ALLEGHENY COUNTY SANITARY AUTHORITY

CONTRACT NO. 1728 G, E, H, P

RAS PIPE AND PUMP REPLACEMENT

ADDENDUM NO. 4

ALLEGHENY COUNTY SANITARY AUTHORITY
WASTEWATER TREATMENT PLANT
RAS PIPE AND RAS PUMP REPLACEMENT
912-A-40
W-2 RAS PUMP STATION EXTERIOR ELEVATIONS

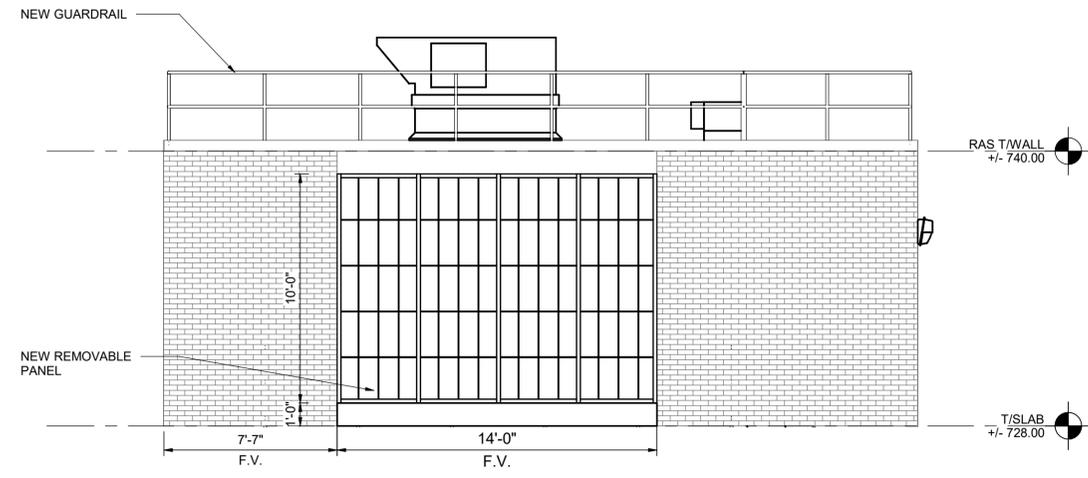
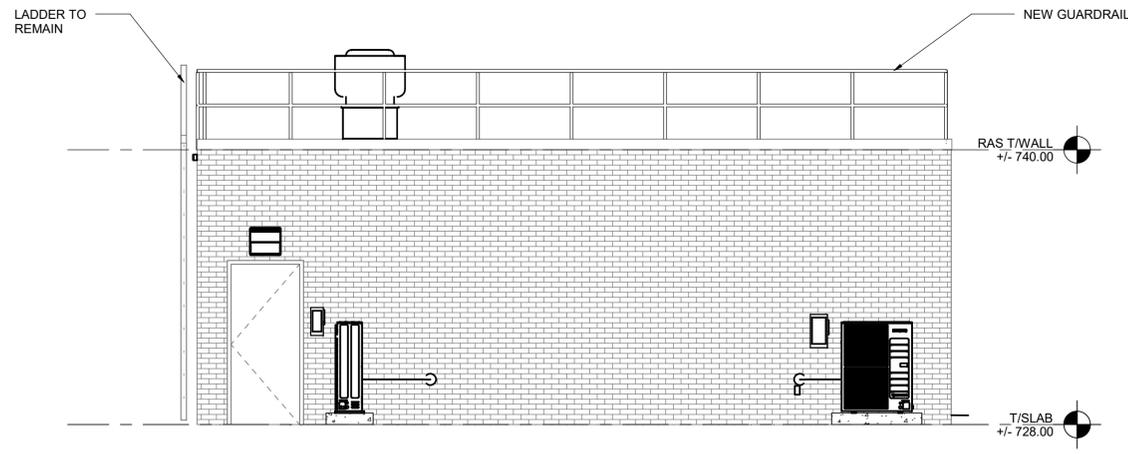
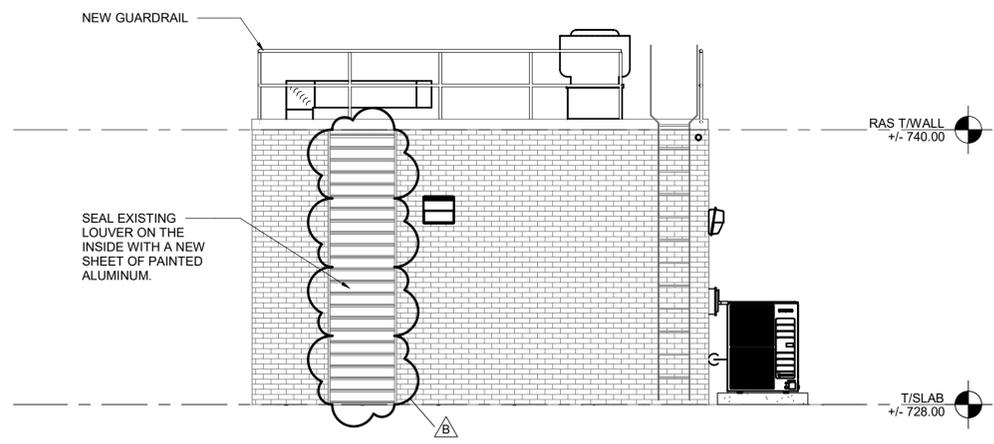
69. **QUESTION:** The elevation drawings for the pump stations as shown on drawing 911-A-40, 912-A-40, 921-A-40 and 922-A-40 are incorrect. There are two full height louvers that require aluminum Blank off panels as per detail F on drawing AD-60. The drawings only show one louver. The same applies for the three stair tower building. There are 2-full height louvers for each stair tower building. Please verify and advise?

RESPONSE: There are two full height louvers in each of the four RAS pump stations and one full height louver at stair buildings 827 and 837 that will have blank off panels per detail AD-60. The related architectural drawings have all been revised via this addendum.
